**BEFORE THE PUBLIC UTILITIES COMMISSION
OF THE STATE OF CALIFORNIA**

Rulemaking 17-09-020
(Filed September 28, 2017)

**CALIFORNIA INDEPENDENT SYSTEM OPERATOR CORPORATION
TRACK 3 PROPOSAL COMMENTS**

Date: March 22, 2019

Figure 1. Summer LCA NQC Example

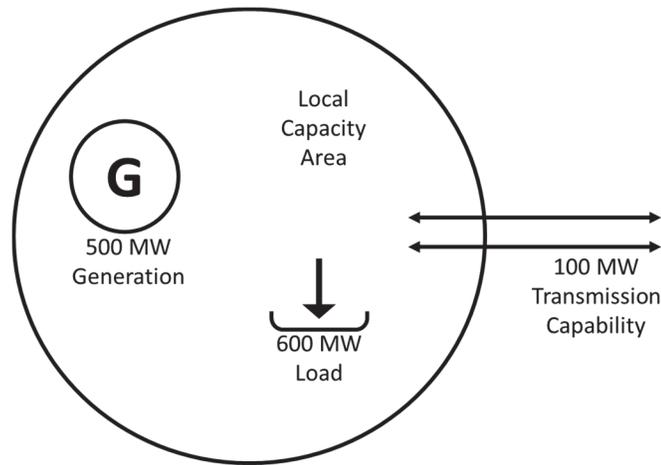
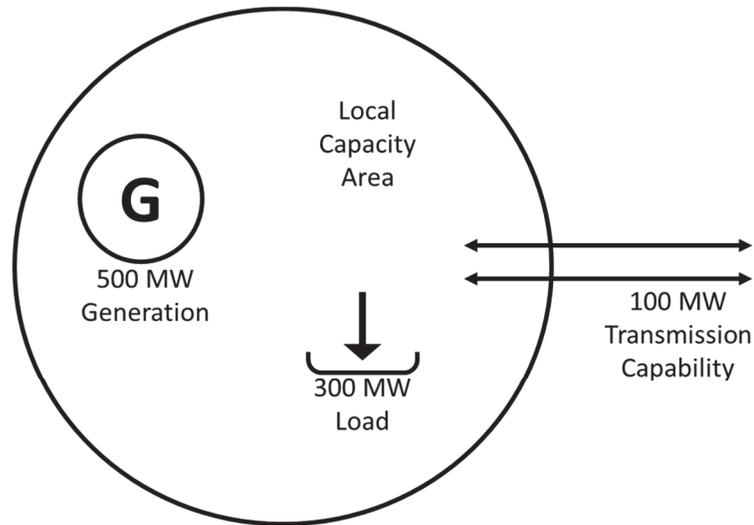
of the local area and into the system for the local area resources to be deliverable. However, the transfer capability out of the local areas during non-summer months can be less than or equal to the transfer capacity during summer months.¹³ As a result, the total energy that is deliverable from within the local area to the aggregate of load during these non-summer months can be less in the summer season. This means that resources in the local area will have their NQC reduced if the energy they produce cannot be fully exported out of the local area. Figure 1 and 2 describe this constraint below graphically as follows:

- Peak internal load conditions
- Internal generation fully deliverable to aggregate of load
- $QC_G (500MW) = NQC_G (500 MW)$

- Internal generation no longer fully deliverable to aggregate of load due to reduced internal load conditions
- $QC_G (500MW) > NQC_G (400 MW)$
